LIBERTY KNITWEAR LTD. (Extension)

19 December 2023

1. Building Information

Observation-4: Storage rack without anchorage (ETP Building).

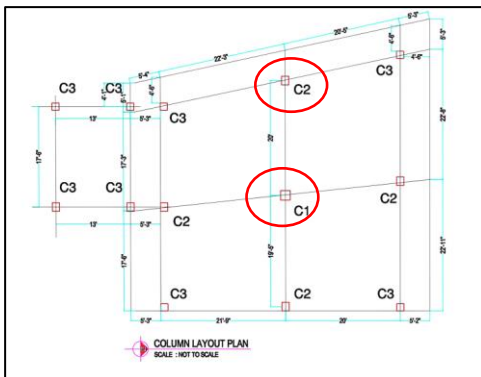
Description: Racks on different floors are not adequately anchored or braced to resist lateral (earthquake) forces. The building engineer is required to adequately anchor and brace all non-structural elements to resist earthquake forces to comply with the BNBC.

Observation-6: Crack in ground floor columns (Canteen Building).

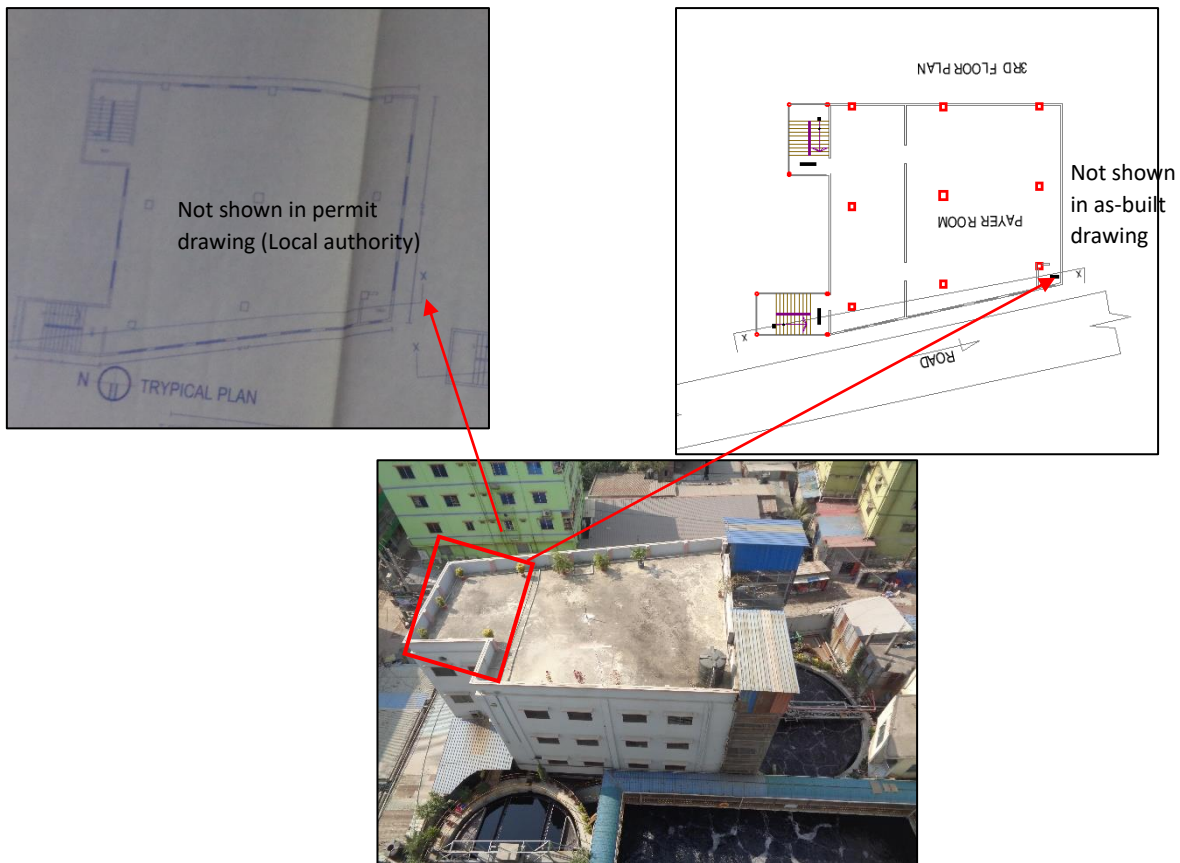
Description: Crack was found in marked columns on the ground floor. The factory must immediately engage a consultant to investigate the cracked column. Any safety measures, if required as suggested by the consultant, must be taken immediately to ensure safety. The investigation report along with the repair methodology must be submitted to RSC by December 24, 2023, and the remediation work must be completed within 7 days of receiving acceptance from RSC. Also, carry out a Detailed Engineering Assessment (DEA) of structure based on in-situ material strength. Take concrete cylinder core from ground floor column to determine the in-situ concrete strength.

Observation-7: Discrepancy in permit drawing and as-built drawing (Canteen Building).

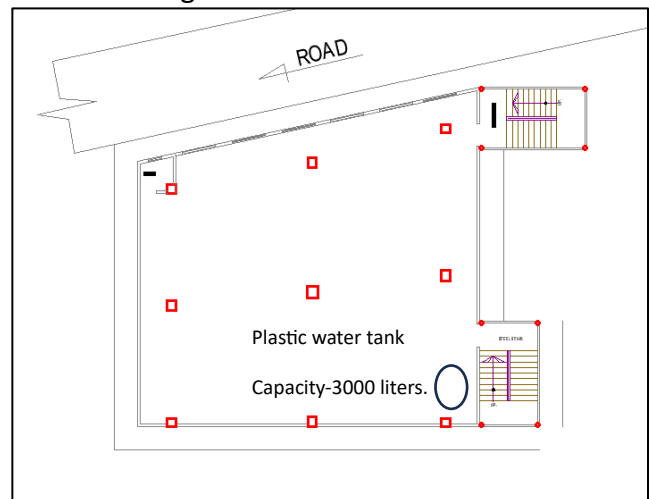
Description: Marked portion at south side is not shown in permit drawing (Local authority) and as-built drawing. The factory is required to collect revised permit drawings from the local authority. Also, the building engineer is required to update as-built drawing.
